Access Compliance Report Public Rights-of-Way (Curb Ramps)

Main Street: SAUVIGNON_DR Cross Street: VINEYARD_RD Location: NW

ADA ID: RPAT211103110743 Ramp Type: Type 4 - Parallel Initial Pass/Fail: Fail Overall Compliance: No Severity Score: 30

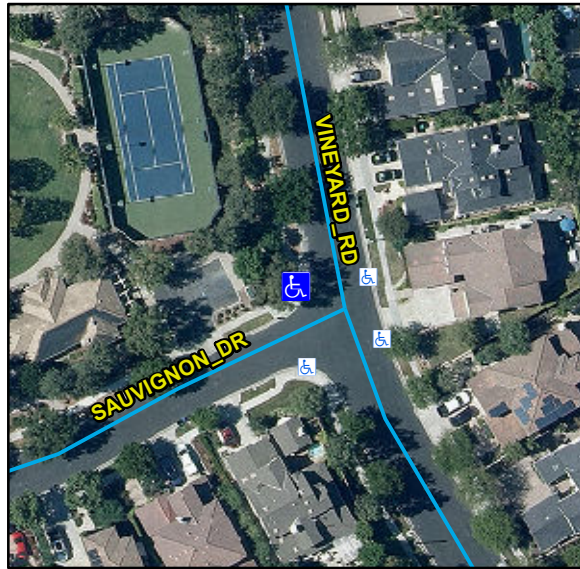
Compliance	Description	Data	Compliance	Description	Data
N/A	Ramp Length LT (in)	108	N/A	Ramp Length RT (in)	100
Yes	Ramp Width LT (in)	52	Yes	Ramp Width RT (in)	52
Yes	Ramp Run Slope LT (%)	1.9	No	Ramp Run Slope RT (%)	13.3
Yes	Ramp Cross Slope LT (%)	0.6	Yes	Ramp Cross Slope RT (%)	0.9
N/A	Landing Present	N/A	N/A	DWS Provided	N/A
N/A	Landing Length (in)	N/A	N/A	DWS Contrast	N/A
N/A	Landing Width (in)	N/A	N/A	DWS Length (in)	N/A
N/A	Landing Run Slope (%)	N/A	N/A	DWS Full Width	N/A
N/A	Landing Cross Slope (%)	N/A		DWS Offset Type	N/A
N/A	Landing Movement Obstructed?	N/A	N/A	DWS Offset Left (in)	N/A
	Landing Movement Type	N/A	N/A	DWS Offset Right (in)	N/A
N/A	Landing Shared	N/A			
N/A	Clear Space	Yes			
N/A	Clear Space To Crosswalk (in)	N/A			
N/A	Marked Crosswalk 1	No	N/A	Marked Crosswalk 2	No
	Crossing 1 Direction	S		Crossing 2 Direction	E
	Marked Crosswalk 1 Width (in)	N/A		Marked Crosswalk 2 Width (in)	N/A

Remove & Replace Curb Ramp With Two New Directional Ramps or Equivalent.
